CLARIFICATION 01

TH. BURUNI LV Cable Network (Power House LV Feeder) Schematic Diagram

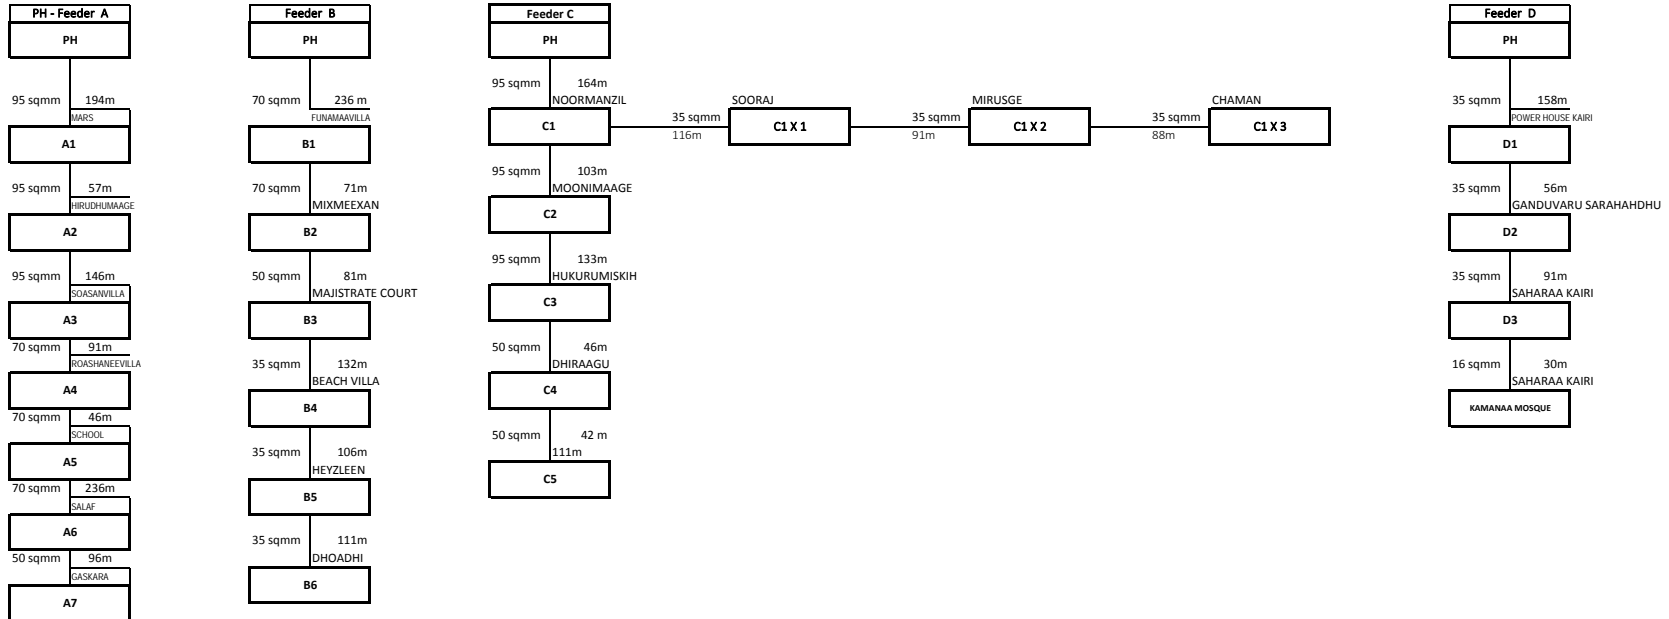
108	Section 6 - ERQ 4.7.7.2.2 Design and Construction	Buildings and structures must be designed for seismic loads. SBC shall be followed.	Please indicate the seismic ground motion parameters	Its bidder's responsibility to identify the parameters which suit the nature of the Maldives.
109	Section 3 – EQC 3-10 2.4.3	For the above or other contracts executed during the period stipulated in 2.4.1	We understand the Contractor who can meet any of the following key activities requirement is qualified, please confirm.	Please refer to section 3.
